RE: Responses to Agency Comments on 2017 Barrier Monitoring Annual Report, Tyco Fire Products LP Stanton Street Facility, EPA RCRA Administrative Order Docket No. RCRA-05-2009-0007; EPA ID No. WID 006 125 215

Response to Comments

FIGURE 1
BARRIER WALL MONITORING
SURVEY COMPARISON RESULTS
GREATER THAN 1-INCH

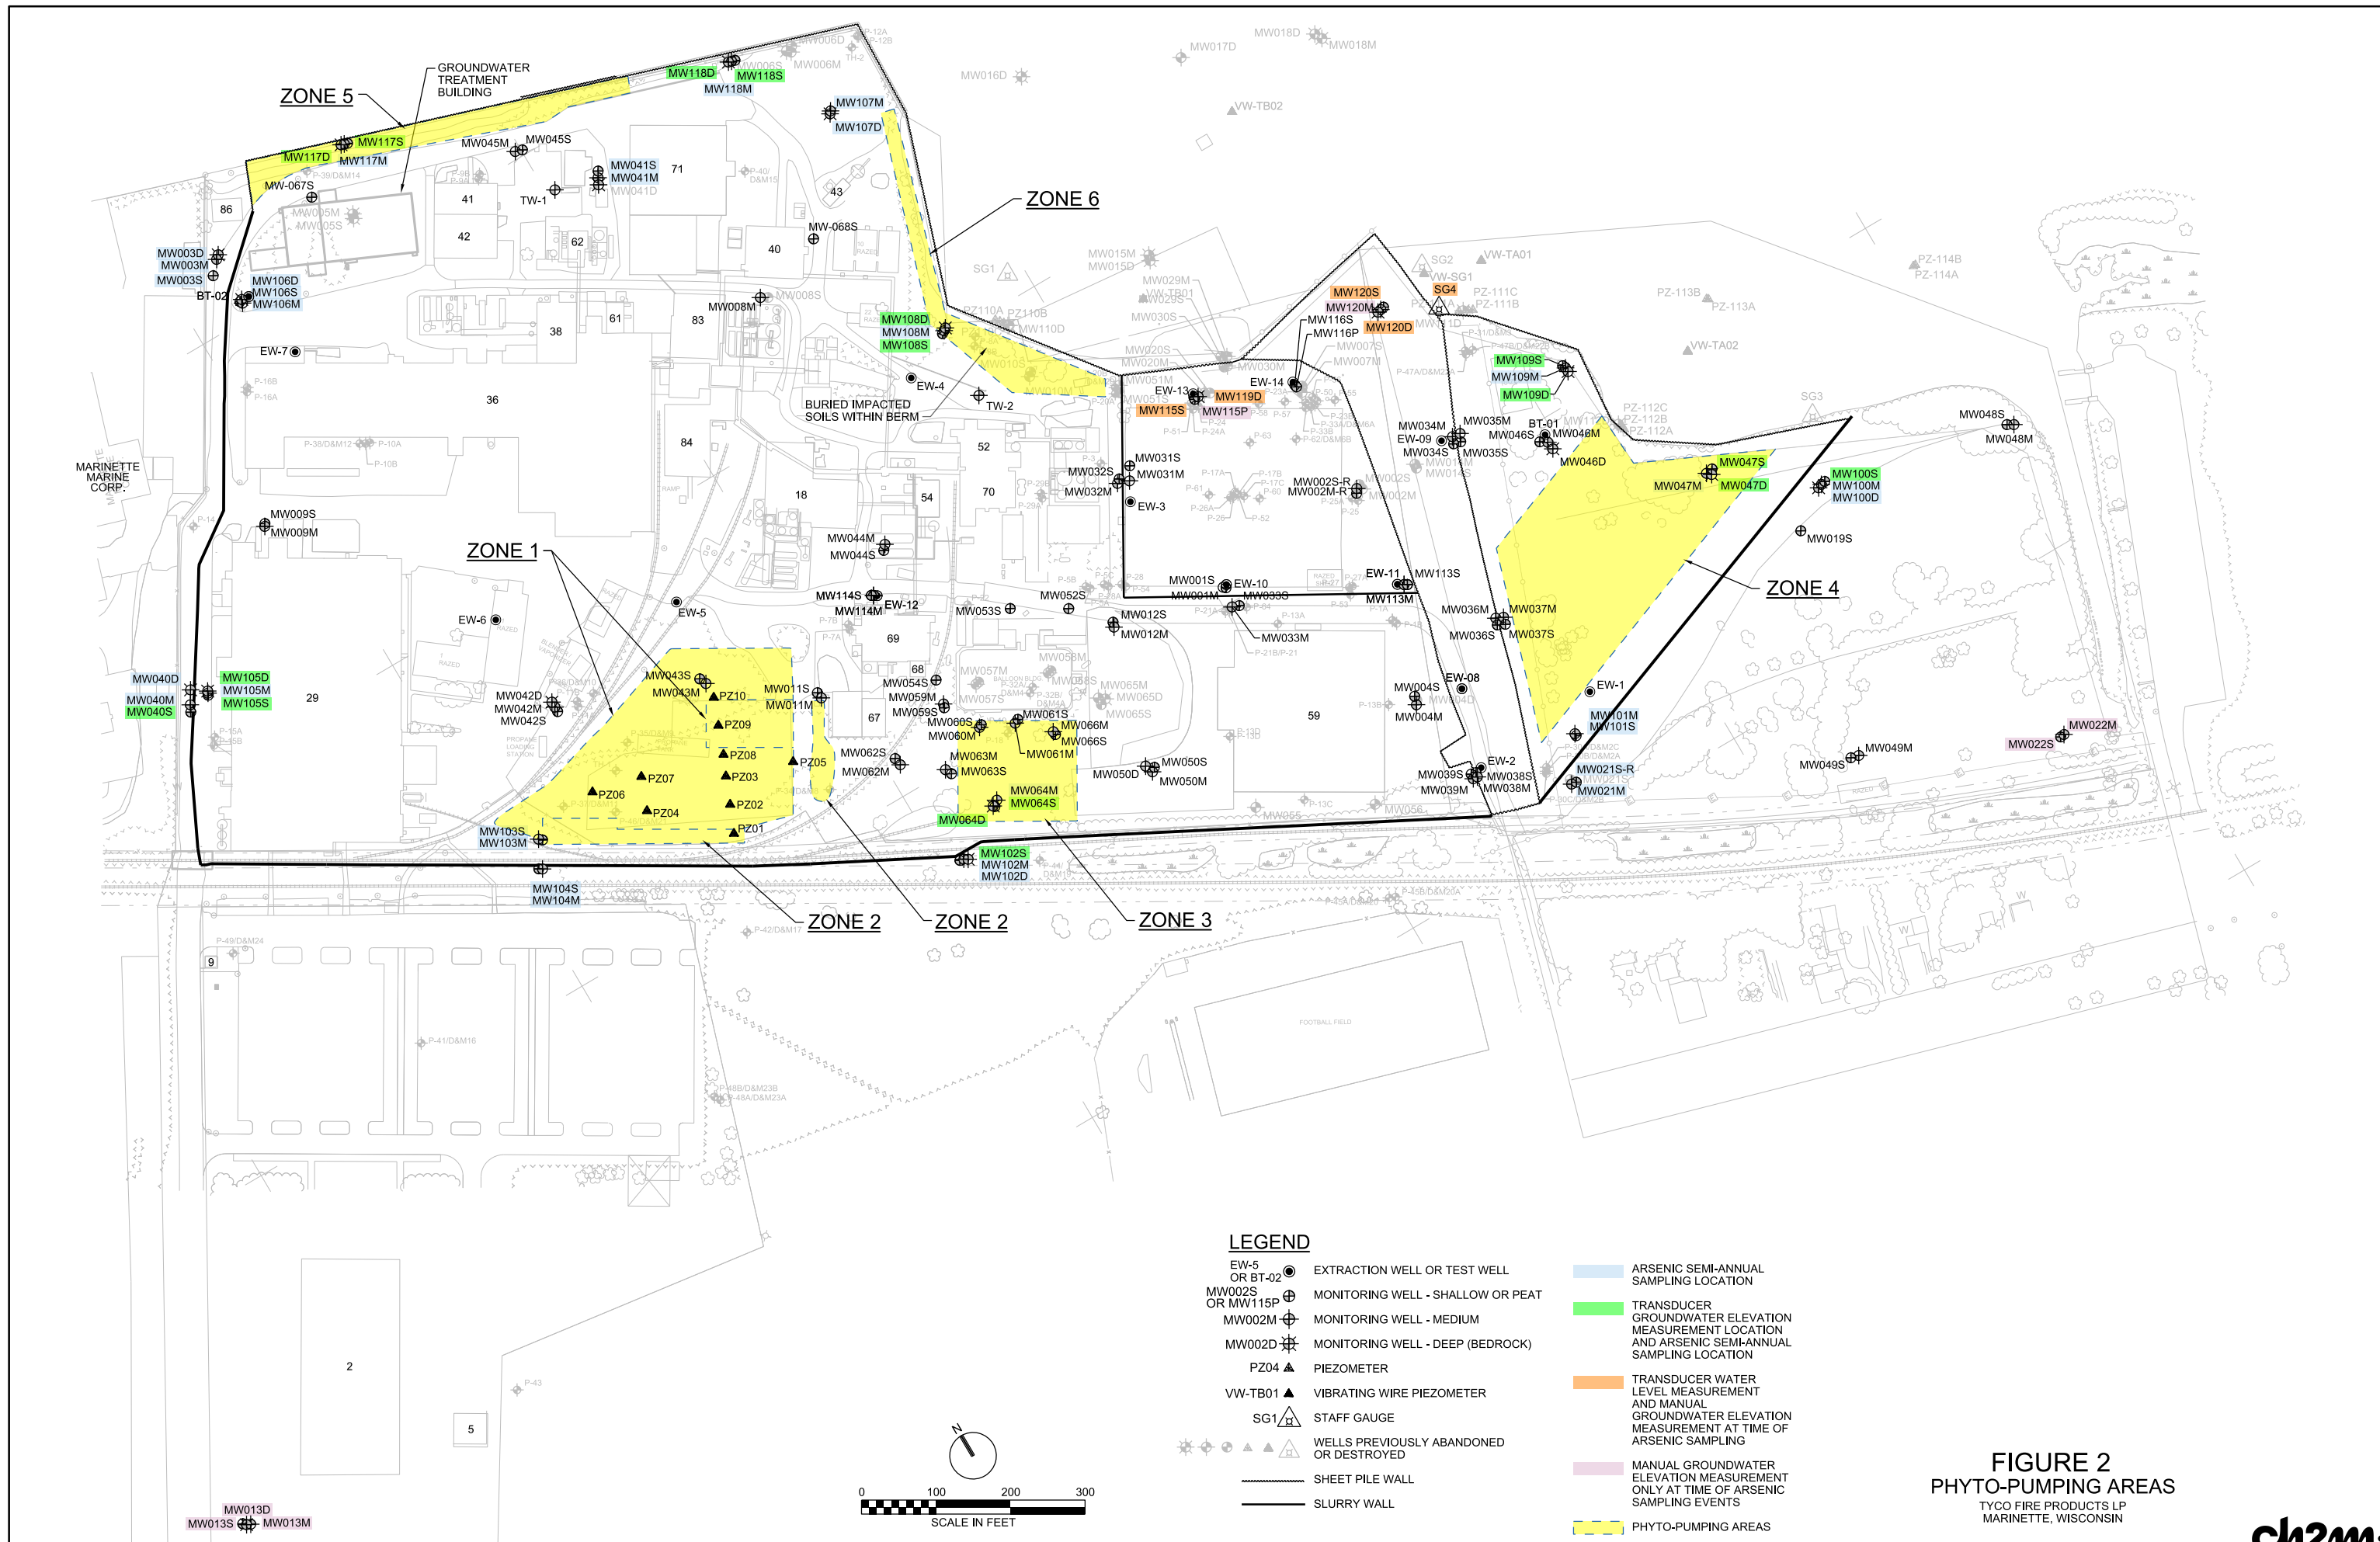
5. *Section 4.4 2017 Barrier Wall Visual Inspection and Surveys – Please include a figure indicating the locations where horizontal deflections exceeding general tolerances were measure, and the size of the deflections.*

Figure 1 shows the dimple locations where horizontal or vertical deflections exceeded 1 inch and the size of the deflections when comparing 2015 (baseline) and 2017 survey data. After reviewing the second paragraph in Section 4.4, there are a few clarifications needed to best present the survey comparison results as indicated below:

The deflections reported are less than 1 inch with the exception of the locations listed in Table 1 and shown on Figure 1 that slightly exceeded 1 inch. The greater than 1 inch of deflection is being used as an indicator to continue to watch those locations as part of subsequent surveys for additional movement or changes noted during inspections. Note that after construction around the wall (the sediment removal work) an inch of movement along the wall the first several of years is common (due to soil conditions adjusting to additional dredging or riprap placement on the water side or loading on the land side). Indications of movement could also be attributed to survey accuracy, temperature stress in the steel, seasonal effects (when comparing surveys conducted in different seasons), and movement in the soil due to short-term loading activities occurring near the wall (such as stockpiling of snow or heavy equipment used in the area). These points will continue to be monitored as part of future surveying and wall inspection activities, paying particular attention for changes such as surface cracks during inspections that can be a sign of movement as well.
